Access Compliance Report

Public Rights-of-Way

(Curb Ramps)

Intersection ID: N/A	Main Street: BALLANTYNE_VILLAGE_DR	Cross Street: N/A	Location: NE
ADA ID: A5BFD18F7730	Ramp Type: Perp	Initial Pass/Fail: Fail	Overall Compliance: No
Severity Score: 25			
Codes/Mitigation Info/Possible Solution		Field Measurements/Component Compliance

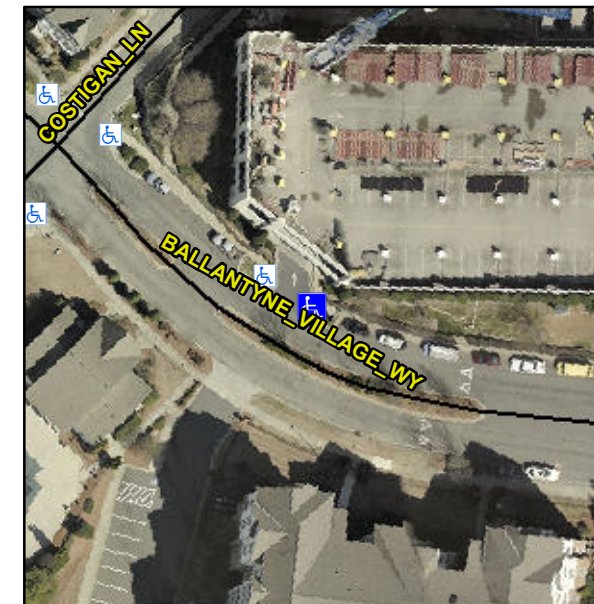
Not Found, R304.5.3

Compliance	Description	Data	Compliance	Description	Data
N/A	Ramp Length (in)	70.0	Yes	Ramp Slope (%)	6.8
Yes	Ramp Width (in)	59.0	No	Ramp XSlope (%)	10.2
N/A	Flare Type LT	N/A	N/A	Flare Type RT	N/A
N/A	Flare Slope LT (%)	N/A	N/A	Flare Slope RT (%)	N/A
N/A	Flare Traversable LT?	N/A	N/A	Flare Traversable RT?	N/A
N/A	Landing Length (in)	N/A	N/A	DWS Provided?	N/A
N/A	Landing Width (in)	N/A	N/A	DWS Contrast?	N/A
N/A	Landing Slope (%)	N/A	N/A	DWS Length (in)	N/A
N/A	Landing X Slope (%)	N/A	N/A	DWS Full Width?	N/A
N/A	Landing Curb? (Y/N)	N/A	N/A	DWS Offset (in)	N/A
N/A	Shared Landing?	N/A			
N/A	Gutter Ponding?	N/A	N/A	Gutter Slope (%)	N/A
N/A	Gutter Lip Ht (in)	N/A	N/A	Gutter X Slope (%)	N/A
N/A	Painted X Walk1?	No	N/A	Painted X Walk2?	N/A
	X Walk 1 Direction	To NW		X Walk 2 Direction	N/A
N/A	X Walk 1 Width (in)	N/A	N/A	X Walk 2 Width (in)	N/A
	X Walk 1 Slope (%)	3.8		X Walk 2 Slope (%)	N/A
	X Walk 1 X Slope (%)	11.4		X Walk 2 X Slope (%)	N/A

Remove & Replace Entire Ramp.
